**LONGHORN ARMY
AMMUNITION PLANT**

**ADMINISTRATIVE
RECORD**

VOLUME 6 of 10

**LONGHORN ARMY AMMUNITION PLANT
KARNACK, TEXAS
ADMINISTRATIVE RECORD - CHRONOLOGICAL INDEX**

FIGURE 1

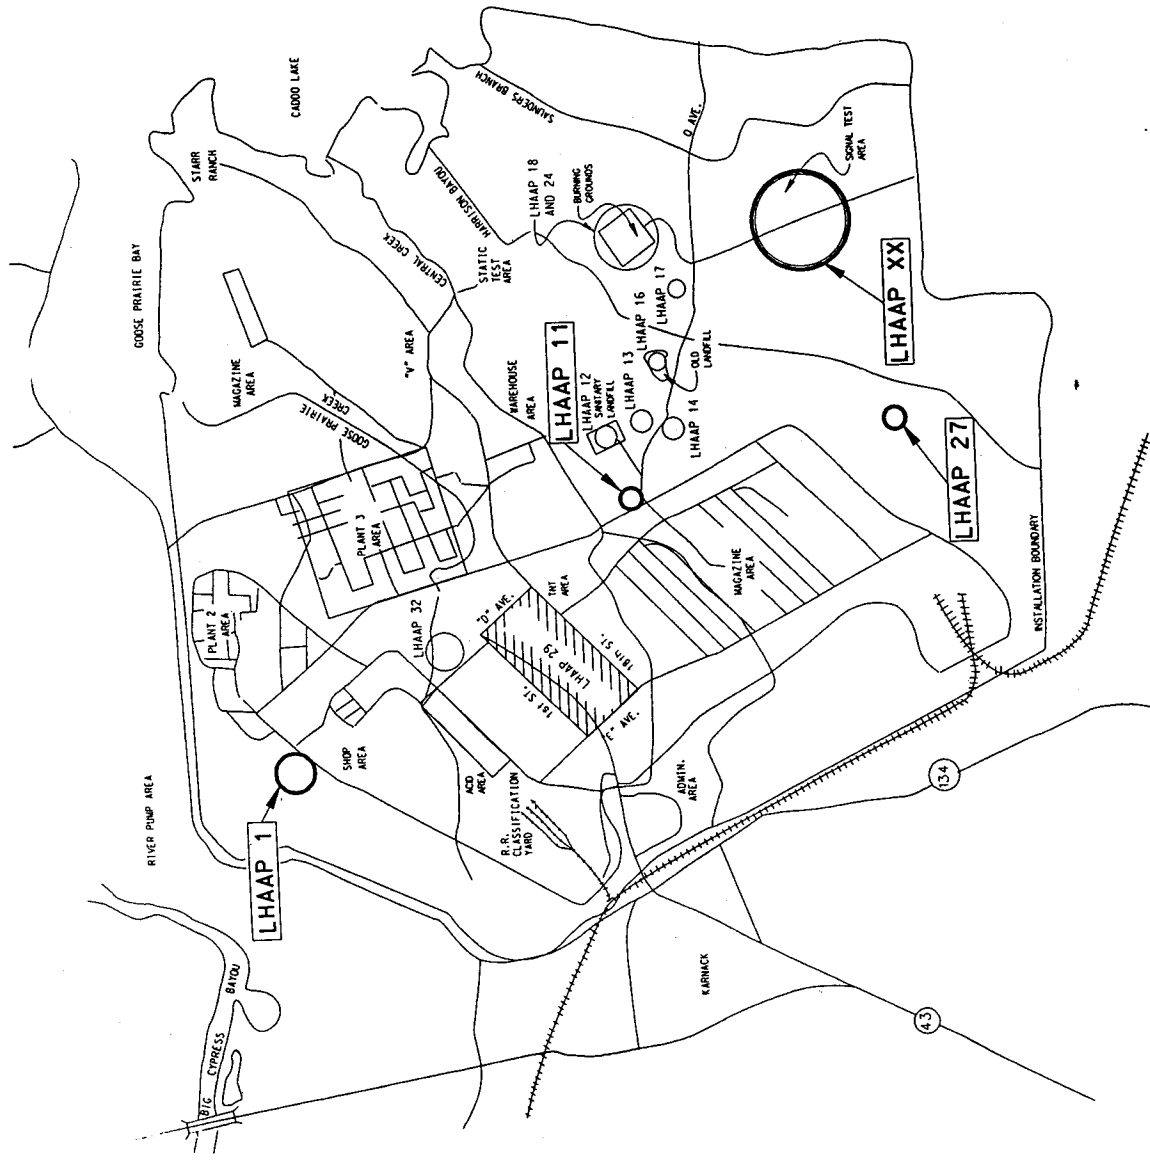
No.	Subject	Comment
1	General - page numbers	Please number pages (at least for commenting purposes).
2	Figure 1: LHAAP, Group 1 Sites (page 1)	This figure is illegible. Needs to be bigger. It is recommended that it be put on its own separate page.
3	PROPOSED PLAN ANNOUNCED (page 1)	First sentence: Insert "United States" before "Department of the Army".
4	General - Subsection titles for sites	First, there exists a lot of inconsistency in the naming of the sites. Under SITE HISTORY, each site is listed by its number/letter and its name. Under SITE CHARACTERISTICS, each site is listed only by number/letter. Under INVESTIGATION RESULTS, each site is being described by both its number/letter and name again. In the CURRENT AND FUTURE HEALTH RISKS section, the titles switch back to number/letter only again. Second, there is a lot of inconsistency on what part (all or only the site number/letter) of the title gets underlined. Finally, the word "site" is sometimes "SITE" and sometimes it is "Site". Please be consistent.
